Service Bulletin

SUBJECT: Mandatory inspection of impulse coupled Slick by Champion magnetos.

SB2-19A Returns
Champion Aerospace Repair Station
1230 Old Norris Rd
Liberty, SC 29657 USA

SERIAL NUMBER LOCATED ON MAGNETO DATAPLATE

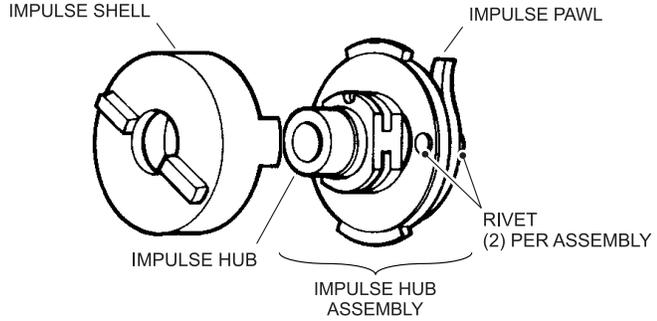
1. Locate magneto serial number on magneto dataplate or purchase date of replacement impulse coupling kits. If the magneto serial number or impulse coupling purchase date is determined to be within the range specified in this bulletin and the dataplate is not stamped with the letter "B" per the WARRANTY description above, remove the magneto from engine in accordance with the latest revision of the engine manufacturer's manual(s).
